ARMY ENGINEER DISTRICT NORFOLK VA  
NATIONAL DAM SAFETY PROGRAM, CRAB ORCHARD CREEK DAM (INVENTORY --ETC(U)  
JUL 80 J A WALSH

Name Of Dam: CRAB ORCHARD CREEK

Inventory Number: VA. 02102

## PHASE I INSPECTION REPORT NATIONAL DAM SAFETY PROGRAM

CRAB ORCHARD CREEK  
N.T.S.  
PLATE 2

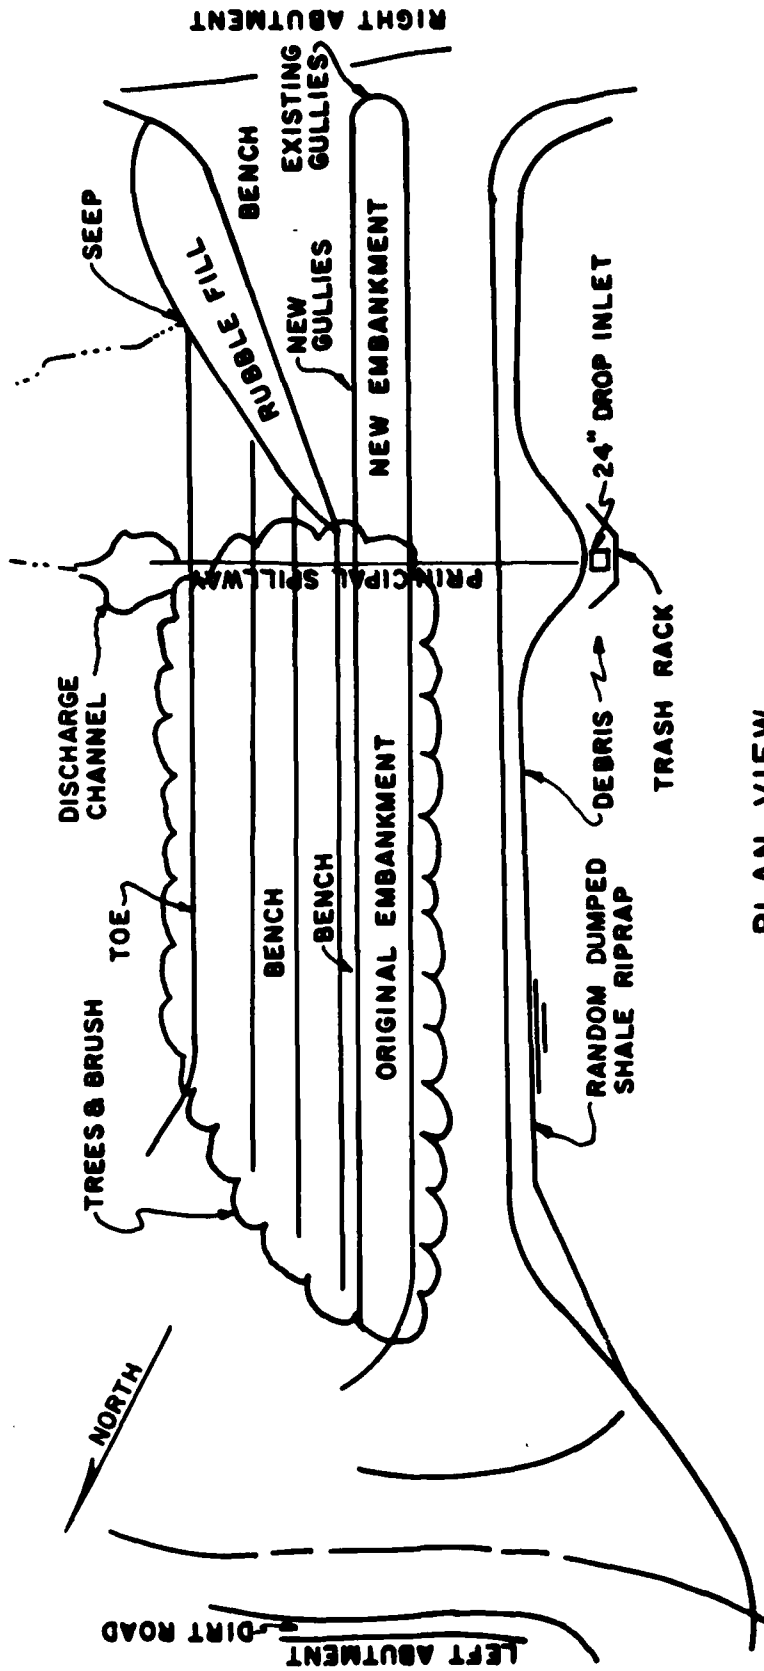
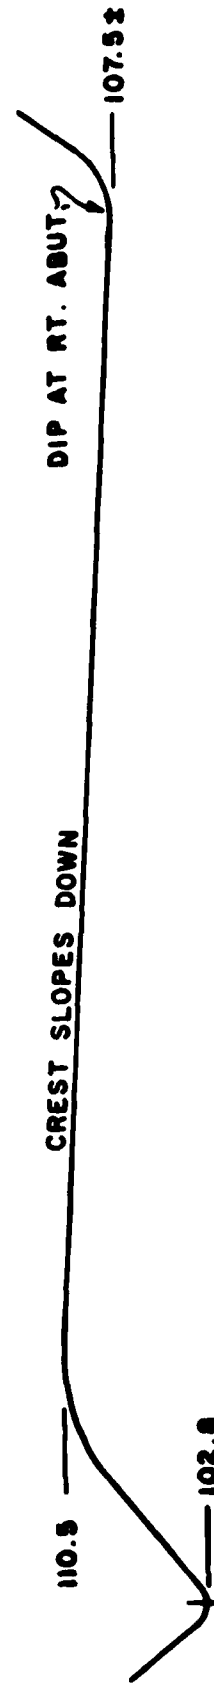
There is one seep located at the base of the dam at the right abutment as shown on Plate II. The origin was not found because of vegetation and boulders inhibiting the inspection in the area. The owner representative said he had checked the spring monthly for the past two years and had noted no changes. Flow is clear. No estimate of the quantity was made. The source and age are unknown.

d. Maintain regular inspection of the seep on the right downstream abutment. Should flow suddenly increase and/or become turbid without explanation contact a geotechnical engineering consultant for further evaluation.

TYPICAL CROSS SECTION

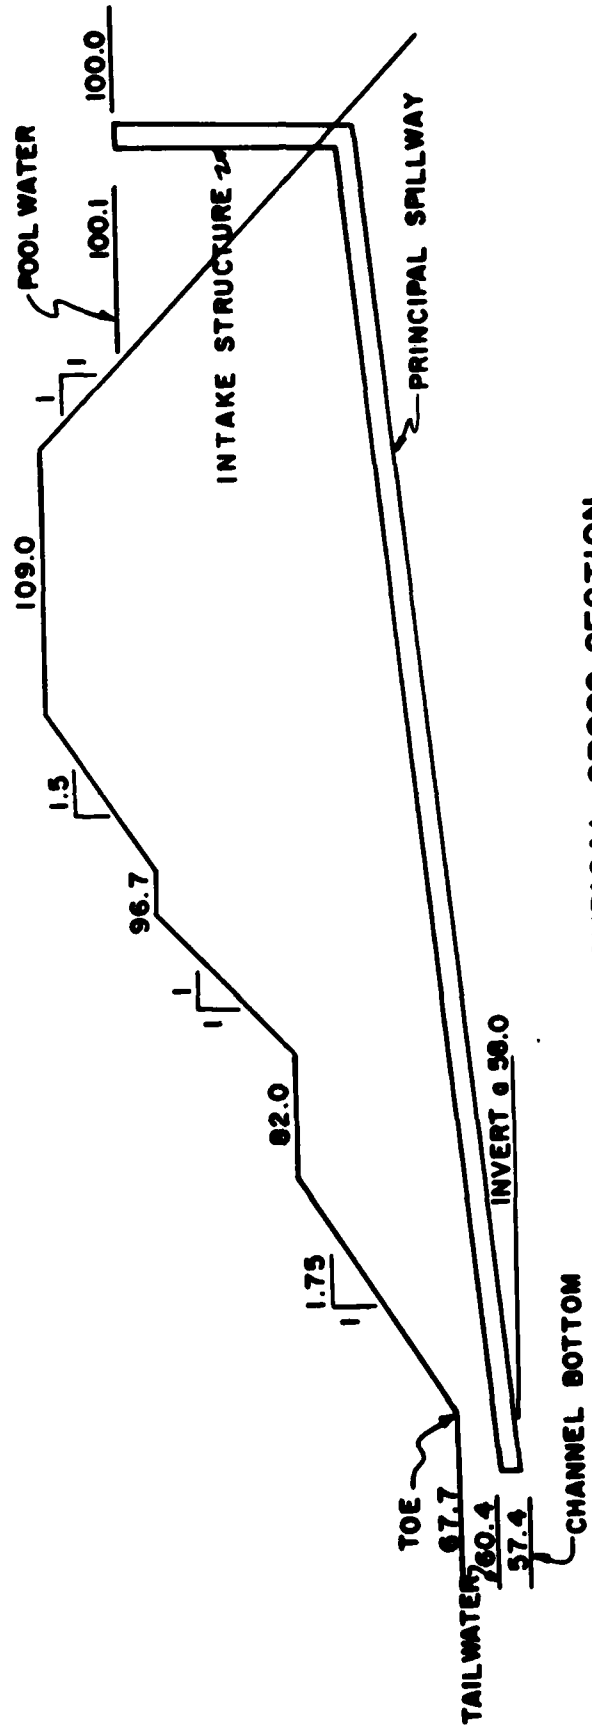
6.2.2 Stability: There are no stability analysis calculations available for this dam, which is 50.5 feet high and 30 feet wide. The upstream slope is 1H:1V with riprap. The downstream slope is double benched. From the crest to the upper bench the slope is 1.5H:1V, to the lower bench it is 1H:1V, and to the toe 1.75H:1V. A plan view, profile of the crest and a typical cross-section are provided on Plates II and III, Appendix I.

b. Perform a stability analysis of the embankment for the long term steady seepage condition. Also, if the emergency gate is ever to be made operable, then a stability check of the upstream slope for a sudden drawdown condition is required.
